Subject: NO COOL AIR FROM AIR CONDITIONER (LEAK FROM EVAPORATOR)	Bulletin No: 07-002/17
	Last Issued: 01/13/2017

BULLETIN NOTE

This bulletin supersedes the previously issued bulletin(s) listed below. The changes are noted below in Red beside the change bars.

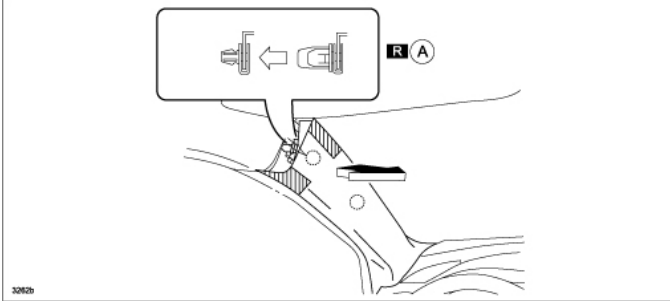
Some customers may complain about no cool air from the vents when the air conditioner (A/C) is ON. This concern may be caused by A/C refrigerant leaking from the evaporator (A) at the joint between the tubes (B) and the header (C) due to improper brazing (D). To correct the problem, the configuration of the header has been changed to improve the brazing performance in this area.
